**CITY PLANNING COMMISSION**  
 1231 "I" STREET, SUITE 200, SACRAMENTO, CA 95814

**APPLICATION:** Variance to allow a detached accessory structure (patio cover) to be located closer than the minimum 6 feet from a residential structure on 0.2± acres in the Standard Single Family (R-1) zone

**LOCATION:** 200 41st Street

P91-001

**EXHIBIT A**

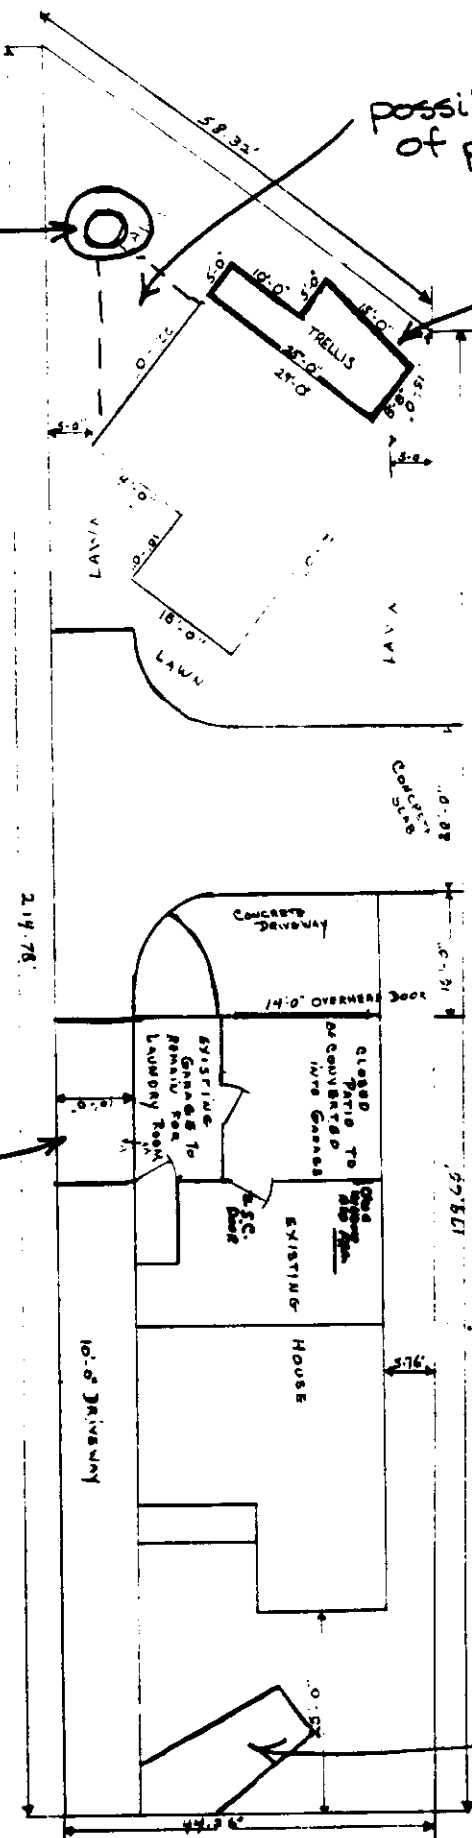
The applicant has partially constructed a detached patio cover in the rear yard of the rear residence that encroaches into the minimum six foot clearance between the accessory structure and the residence. According to the Zoning Ordinance, a detached accessory structure that is located at least 60 feet from the front property line may be located within the rear and side yard setbacks and must be located at least six feet from any residential structure. The applicant is proposing to complete a detached patio cover that is two feet from the wall of the existing residence so a variance is required.

The subject site has a diagonal rear property line and the second residence is located at an angle parallel to the rear property line in order to meet the 15 foot rear yard setback requirement. The orientation of the house on the lot creates few places to locate a patio cover. Staff suggests locating an attached patio cover on the south side of the house near the satellite dish as indicated on Exhibit A.

Staff recommends denial of the Variance to allow a detached accessory structure to be located closer than six feet from the residence in that no hardship can be found to allow the encroachment, the proximity of the covered patio to the adjacent properties creates a possible nuisance to those property owners, an alternative location for an attached patio cover exists, and a shade tree planted on the lot could be used to provide shade.

EXHIBIT B

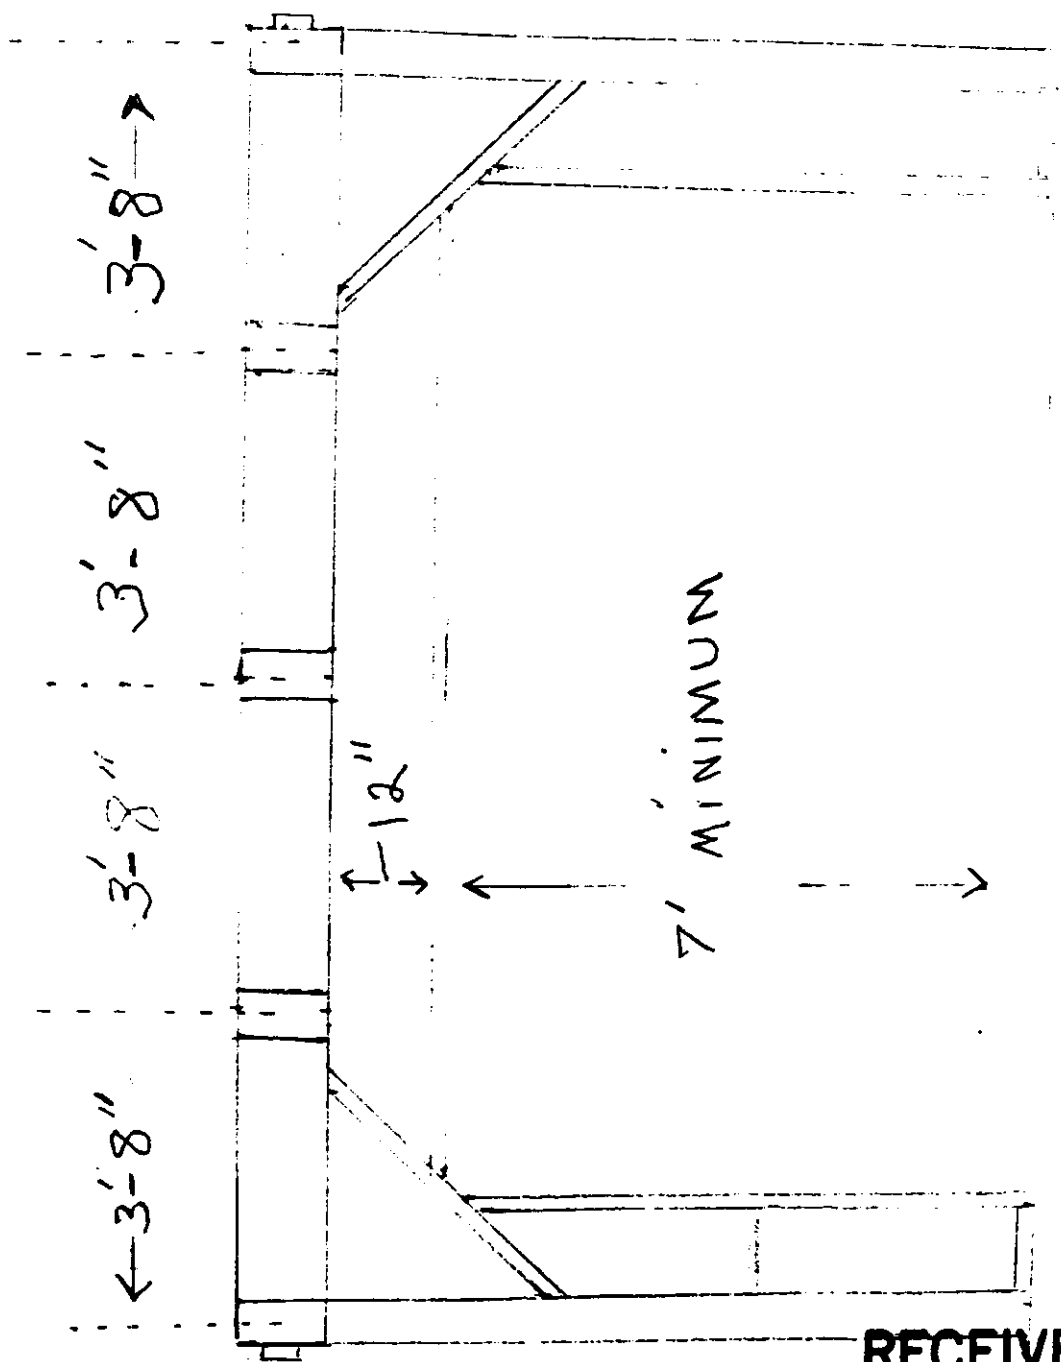
The applicant has partially constructed a detached patio cover accessory structure for a single family residence that encroaches into the minimum six foot clearance between the accessory structure and the residence (see Exhibits A, B, and C). The applicant is requesting the necessary variance to allow the patio cover to be completed.
